**DEVIATION REQUEST
 AND DECISION FORM**

Project Name : Saddlehorn Ranch – Filing 2
 Schedule No.(s) : 4300000601, 4300000602
 Legal Description : SEE ATTACHED – Exhibit C

A deviation from the standards of or in Section **ECM section 2.3.4.A.2, Table 2-14** of the Engineering Criteria Manual (ECM) is requested

SADDLEHORN RANCH K VALUE VARIANCE EXHIBIT

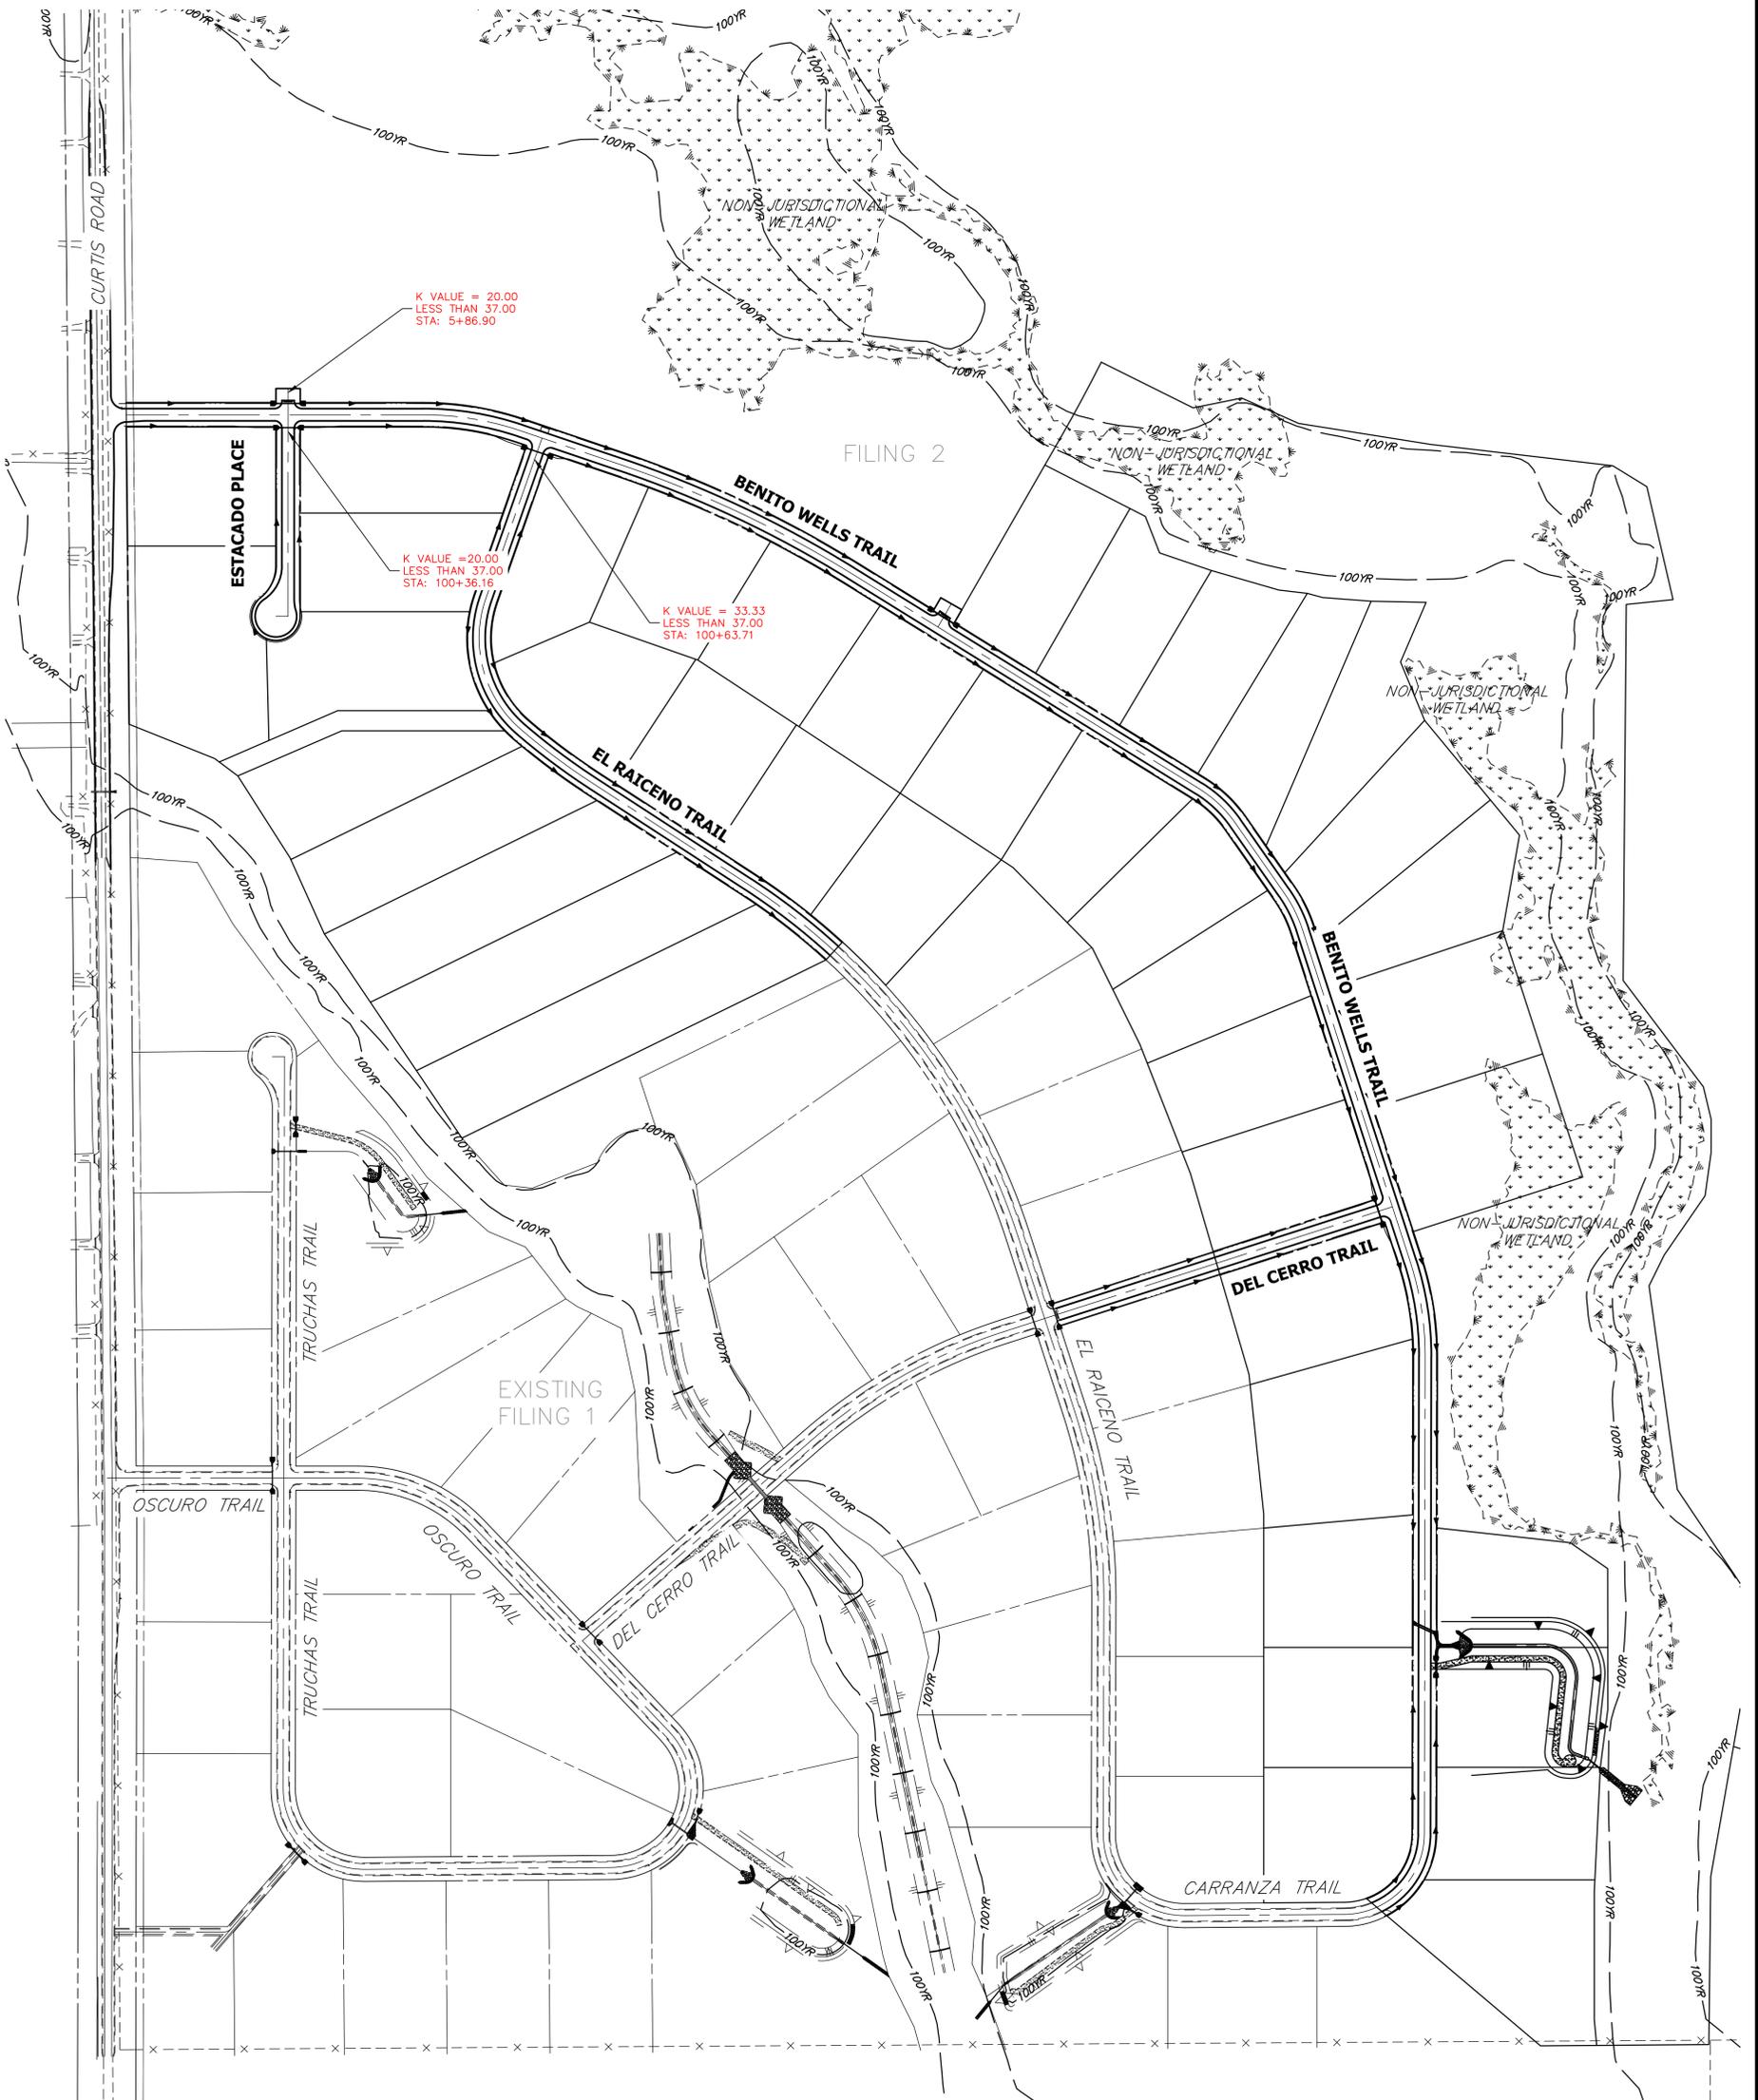
Criteria for K values of a sag curve with a design speed of 30 MPH is 37, per Table 2-14 of the El Paso County Engineering Criteria Manual. The following request will be to deviate from this minimum K value and use a K value of 20 for sag curves at intersections with stop conditions.

In order to construct the roadside swales with adequate longitudinal slopes, the K value for stop condition intersections has been reduced from 37 to 20. This allows the swales at these intersections to maintain adequate depths and slopes as drainage is conveyed through the intersection.

For design speed limits of 30 MPH, a sag curve requires a K-value of 37, per Table 2-14 of the ECM. This deviation proposes a reduction of this K-value for stop-controlled intersections only. This reduction allows the roadside drainage swales to maintain an appropriate longitudinal slope to adequately convey drainage away from the intersections.

This request has been determined to have met the criteria for approval. A deviation from Section 2.3.4.A.2, Table 2-14 of the ECM is hereby granted based on the justification provided.
